Technical Bulletin 203
12.2019

Item	Subject	Model Affected
203.1	Rear Bevel Box Breather	Rocket 3 GT, Rocket 3 R, Rocket 3 TFC

- 1. Breather
- 2. Bevel box

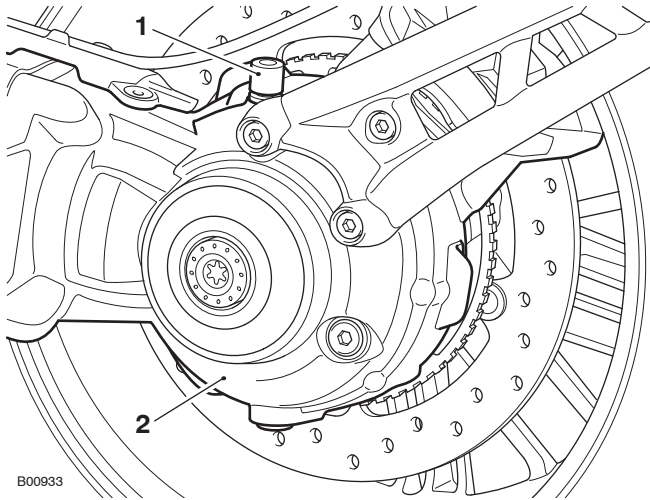
For the above models from VIN 971688 the rear bevel box is fitted with a breather.
 Before washing the motorcycle make sure the engine and the rear bevel box are cold.
 While washing the motorcycle care must be taken when cleaning the rear bevel box to make sure water does not enter the breather.
